Reference: #15s1154000

22 June 2015

#### RE: PROPOSED REDEVELOPMENT OF LUCAS GARDENS SCHOOL 121 QUEENS ROAD, FIVE DOCK (DA 2015/0092) RESPONSE TO ENGINEERING COMMENTS & REVISED VEHICLE ACCESS

Attachment A – Revised Site Plan

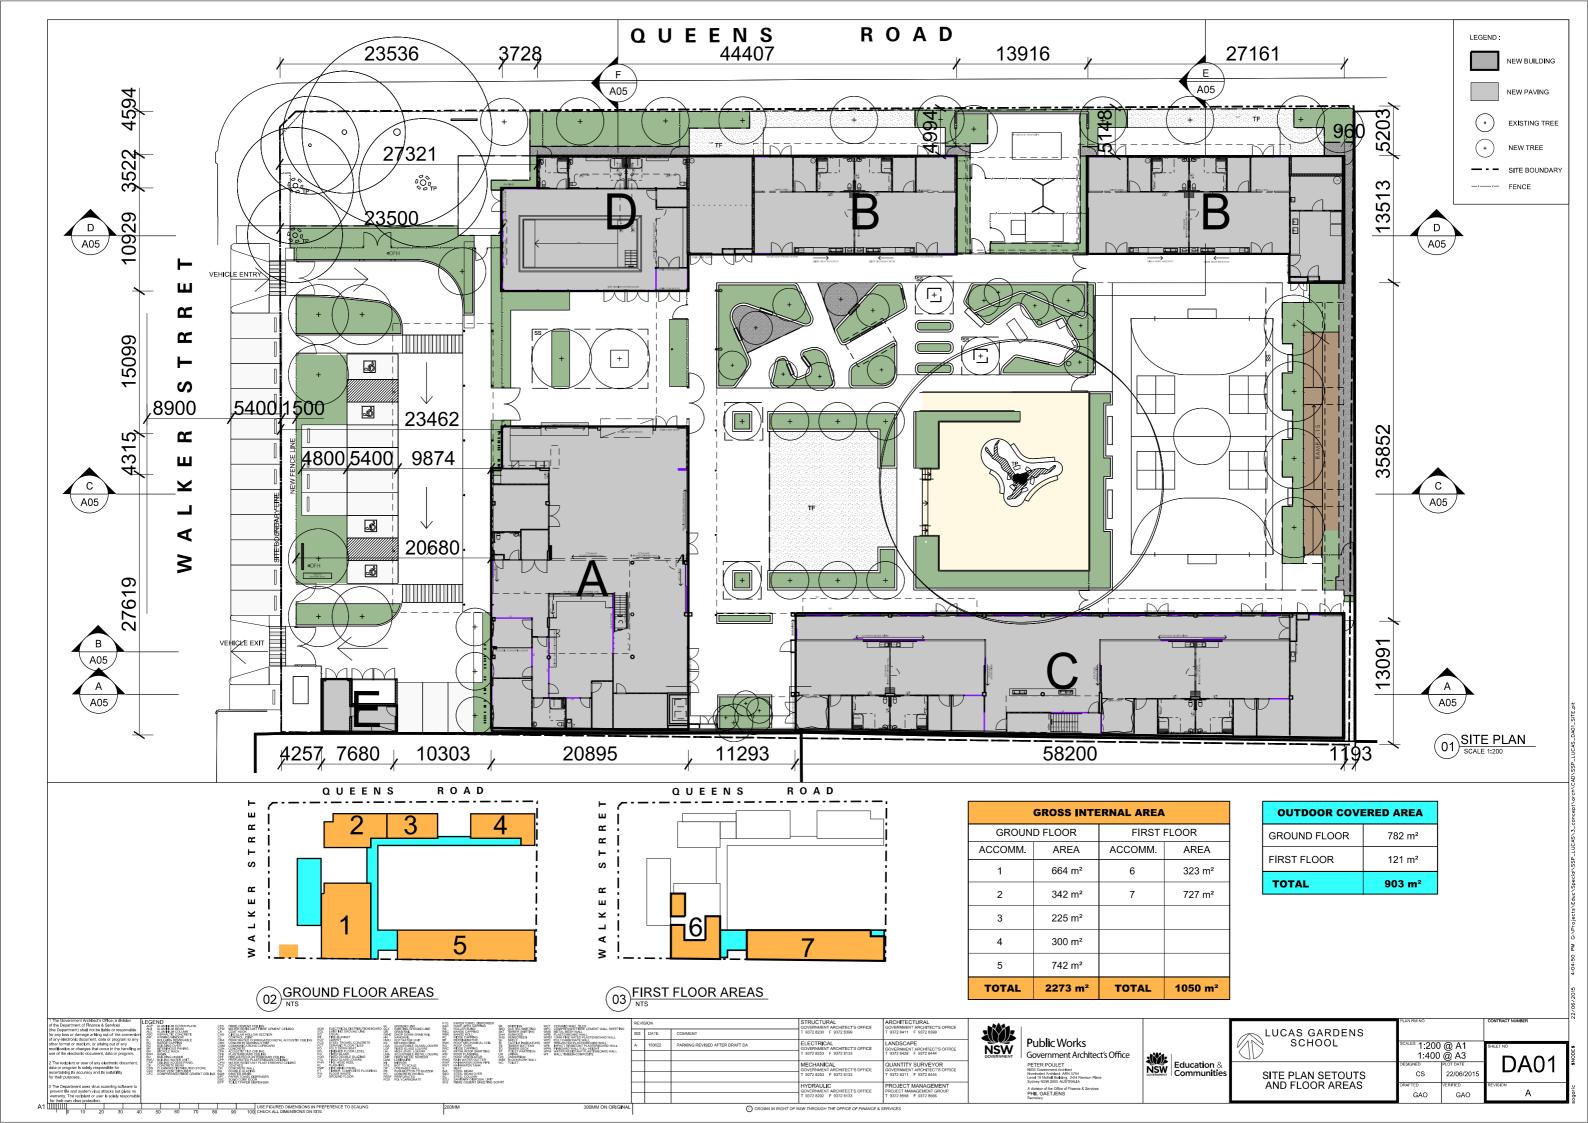
Based on the discussions, modifications to the proposed vehicle access and parking arrangements have been made to address Council's concerns and comments. These changes are contained in the revised "Site Plan" provided in Attachment A.

The entry and exit driveways have been swapped as per Council's request with the northern driveway proposed to be an entry driveway and the southern driveway to be an exit.

To accommodate vehicle manoeuvring to and from the proposed 90 degree angle parking along Walker Street in a manner which is consistent with the objectives of AS2890.5 the width of the parking spaces has been increased to 2.7m wide and set back from the existing kerb line.

Under this arrangement the first driveway that vehicles seeking to access the site encounter will be the entrance.

These changes have the effect of increasing the available road pavement for vehicle manoeuvring and reducing the tightness of the vehicle approach angle to the parking spaces.
